ADDENDUM

Project Name:	Hamtramck Public Schools HVAC Upgrades Phase 2	Addendum No:	Two (2)
Project Number:	22-118	Issue Date:	September 21, 2022
Project Location:	Hamtramck, Michigan

To the Contract Documents for the requested: **HPS HVAC Upgrades Phase 2**

SHEET NO.
 A3-03

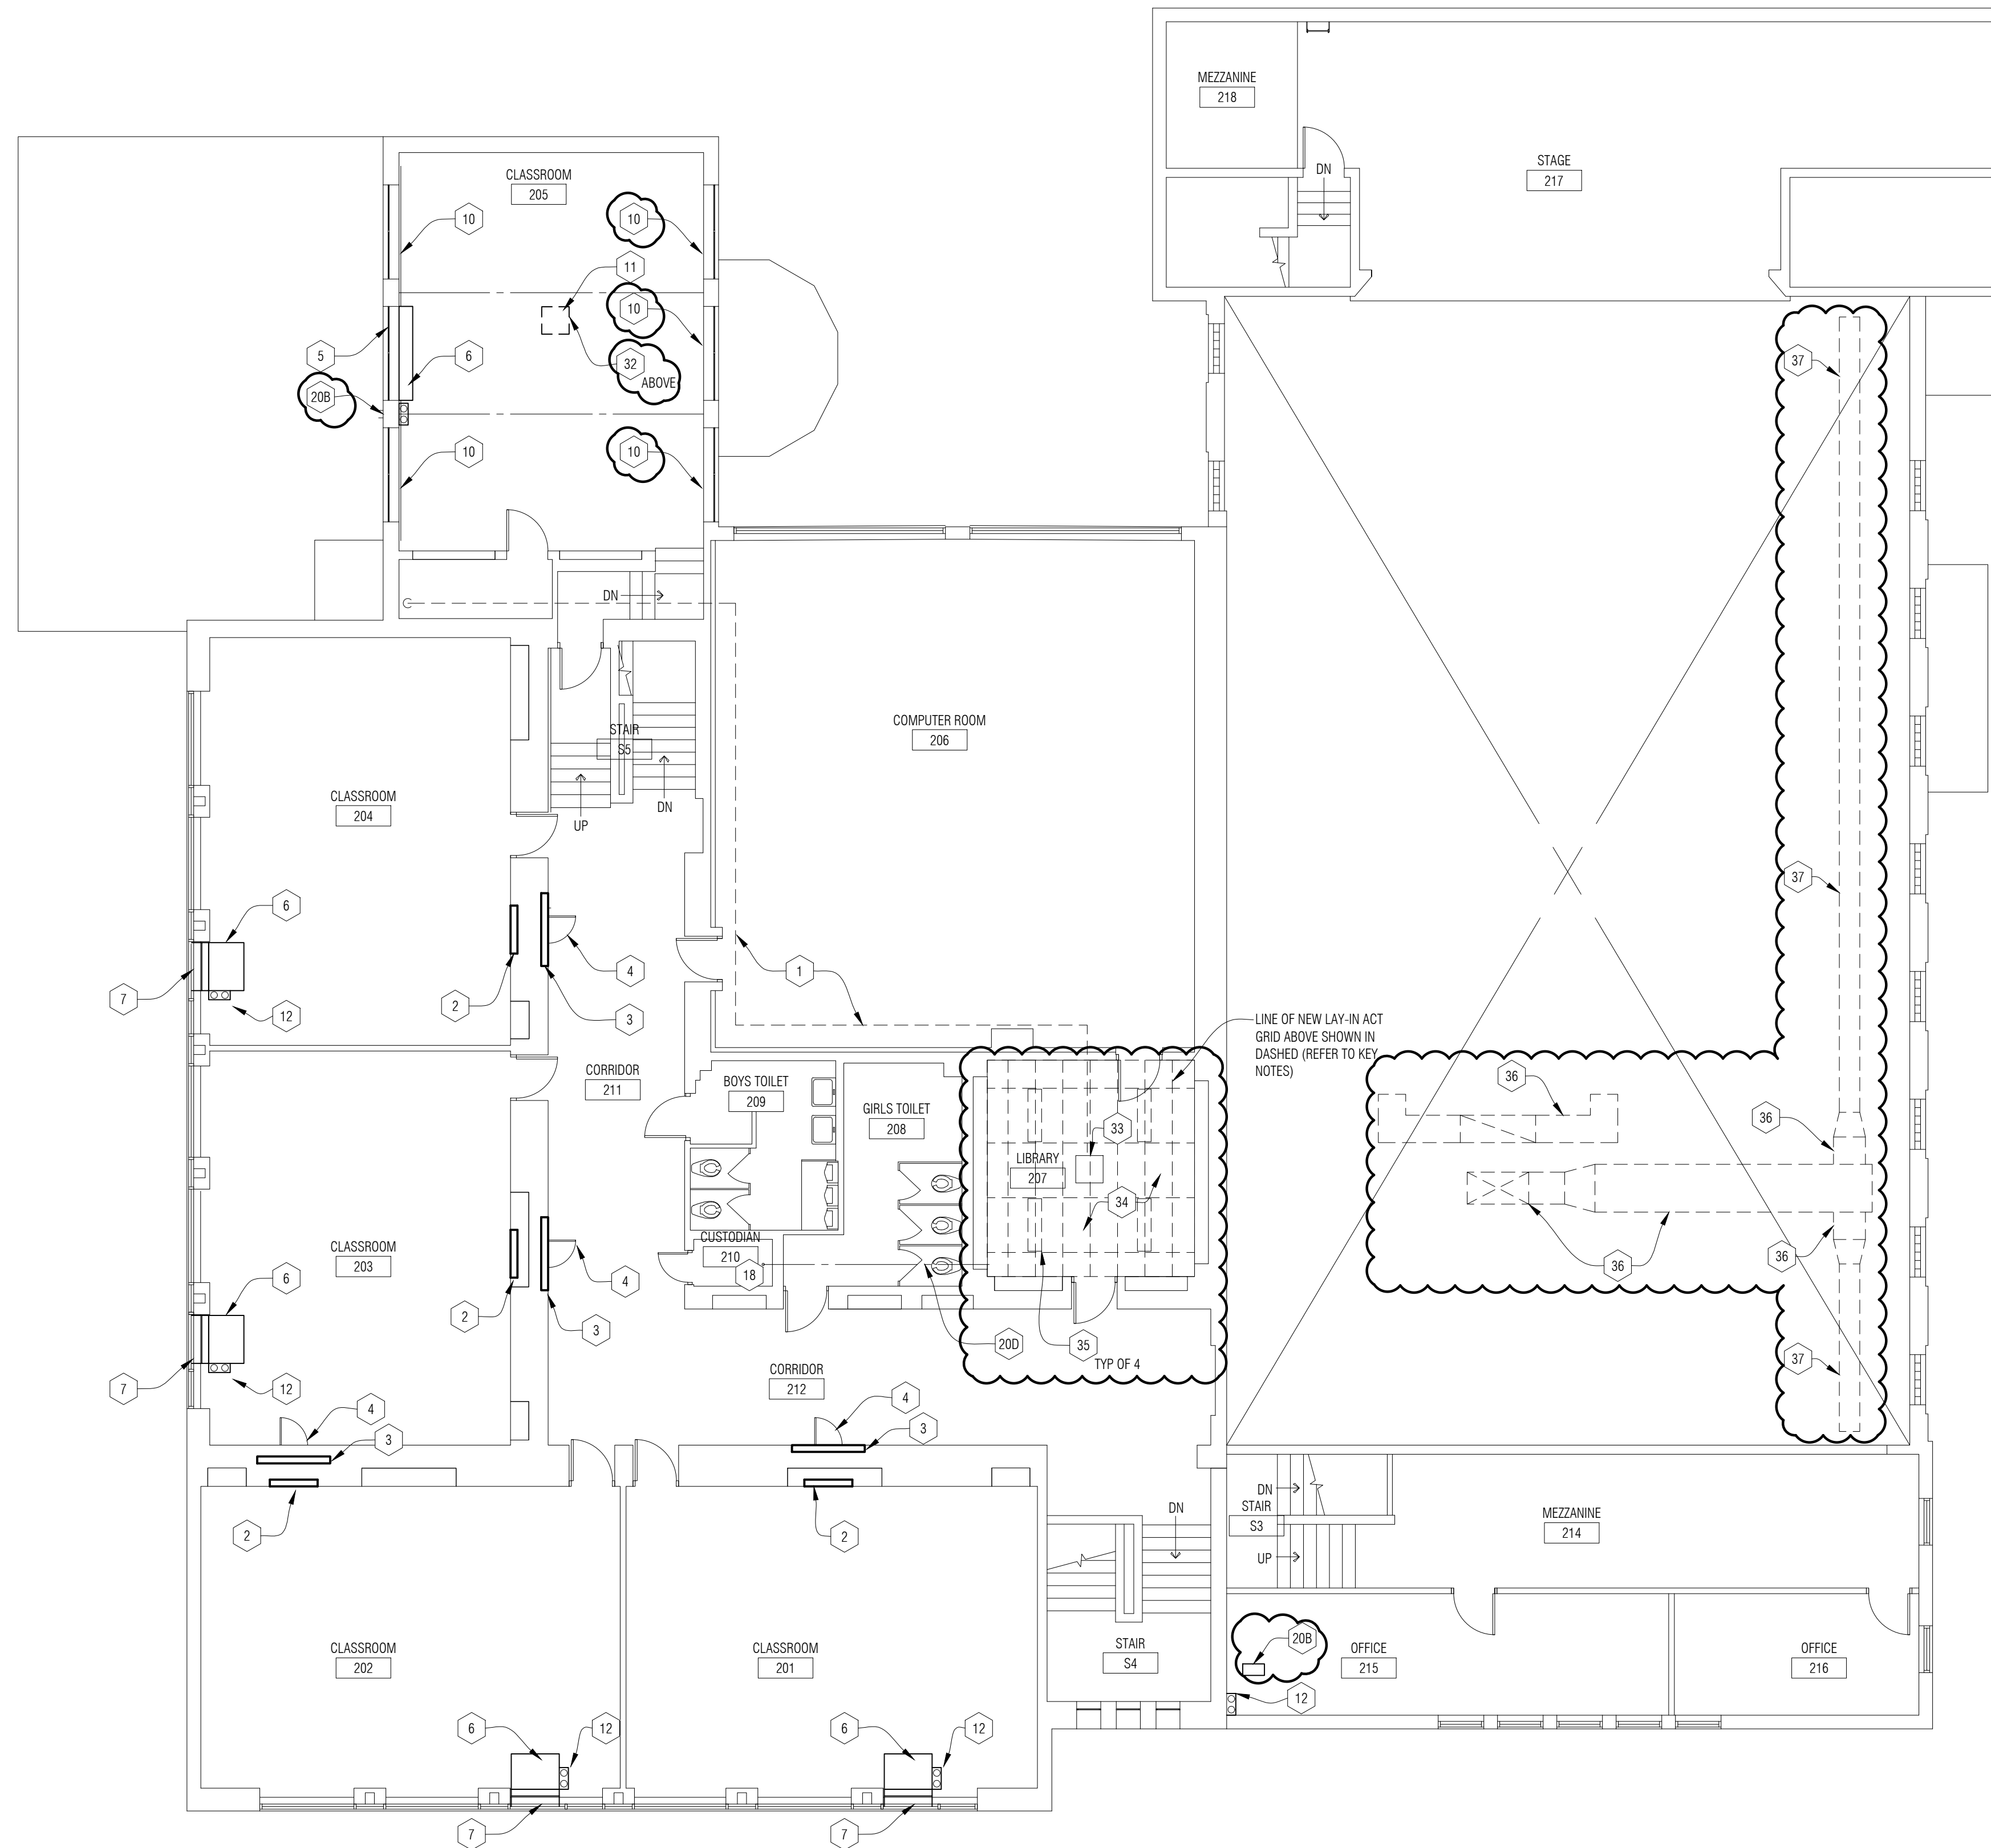
A. Scope clarification and key note update
B. Room finish scope changes.
C. Finish application for new mechanical equipment in gym area.
- Item A8** Drawing 3-20; DEMOLITION and NEW WORK ROOF PLAN (revised but not re-issued)

3 Detail @ Window Header
 A4-01 1-1/2" = 1'-0"

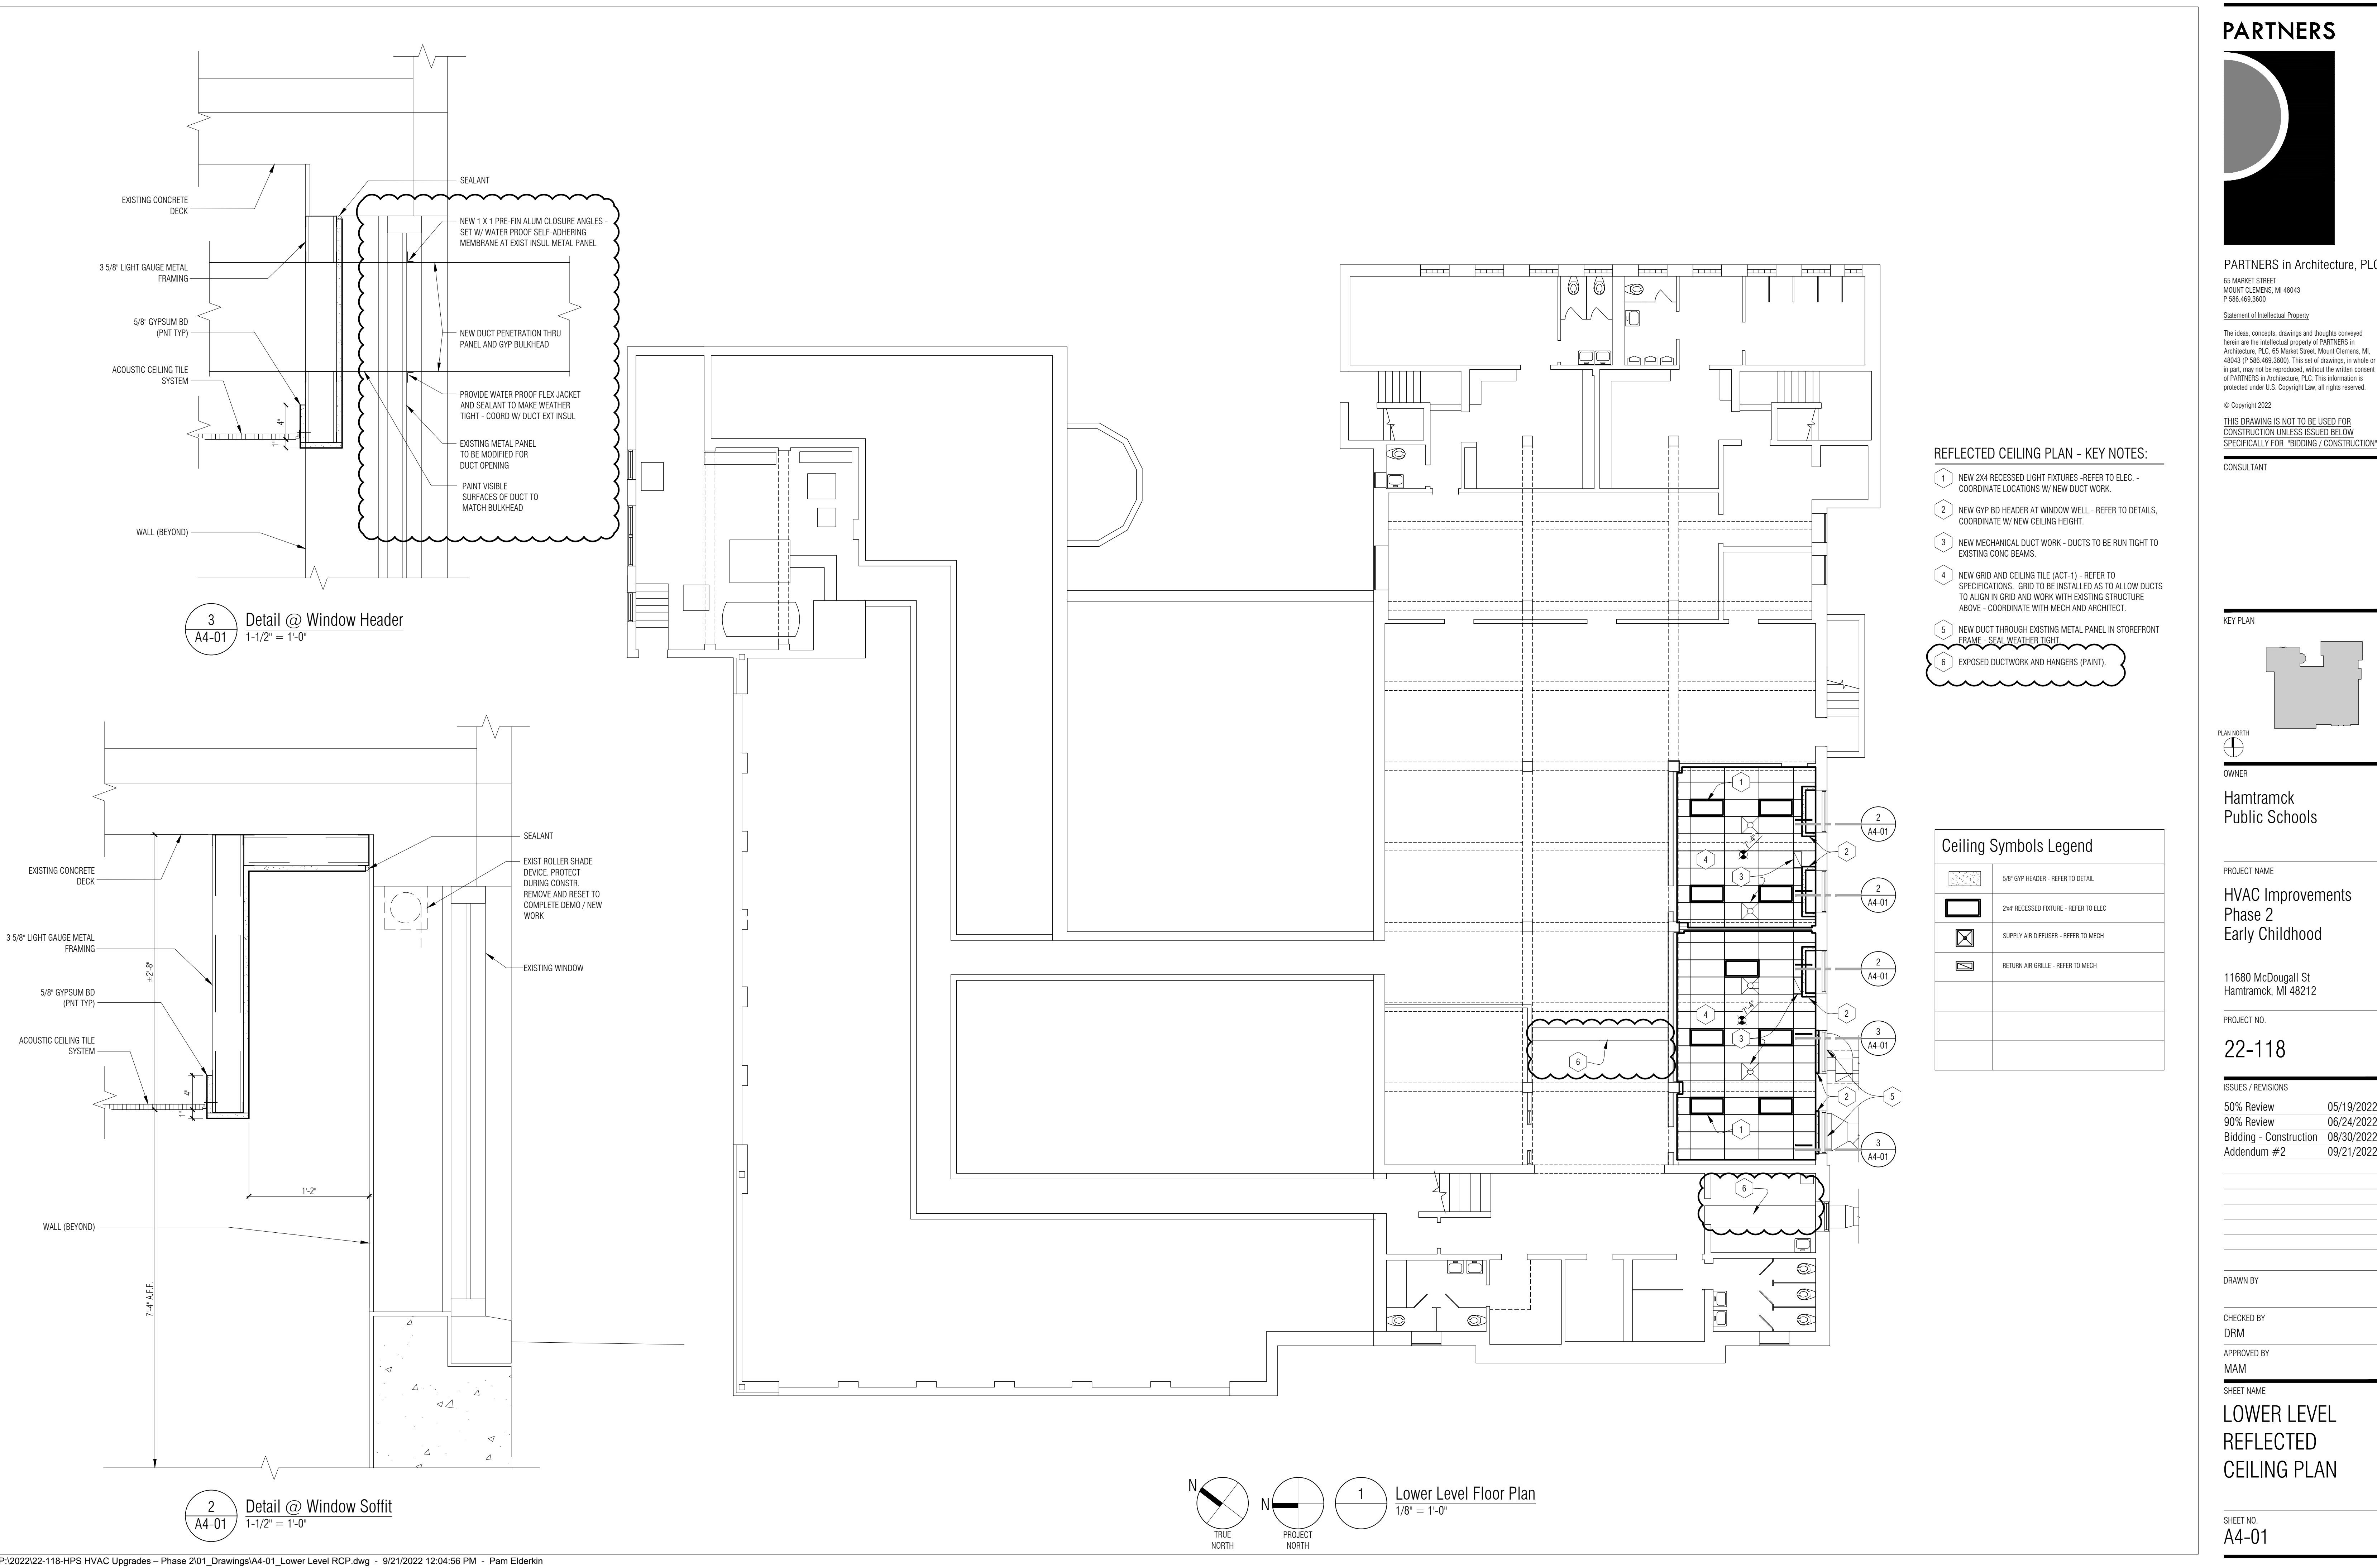
A. Scope clarification and key note update
B. Detail adjustment for mechanical duct installation through metal panel and gyp board header.
- Item A10** Drawing A5-01; EXTERIOR ELEVATIONS (re-issued)

2 South Exterior Elevations
S3-01 1/8" = 1'-0"

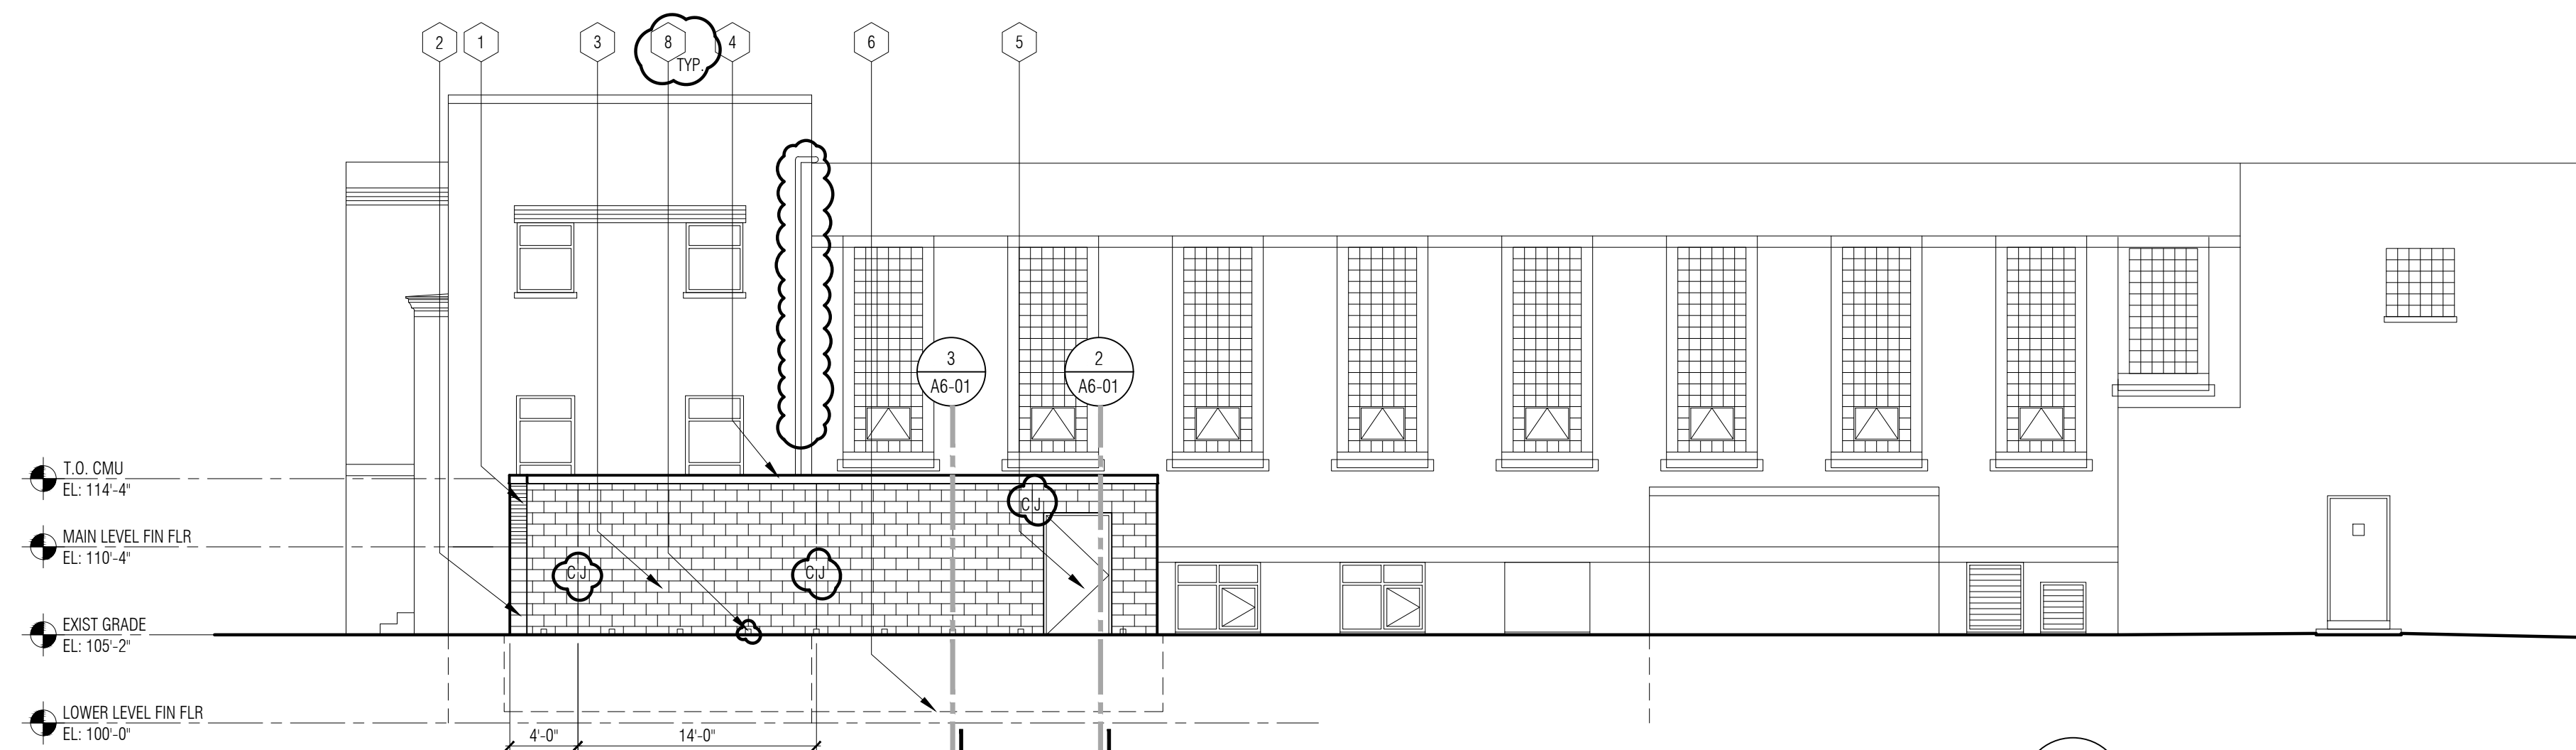
A. Scope clarification and key note update.
B. Layout and utility piping coordination changes.
- Item A11** Drawing A6-01; WALL SECTIONS and DETAILS (re-issued)
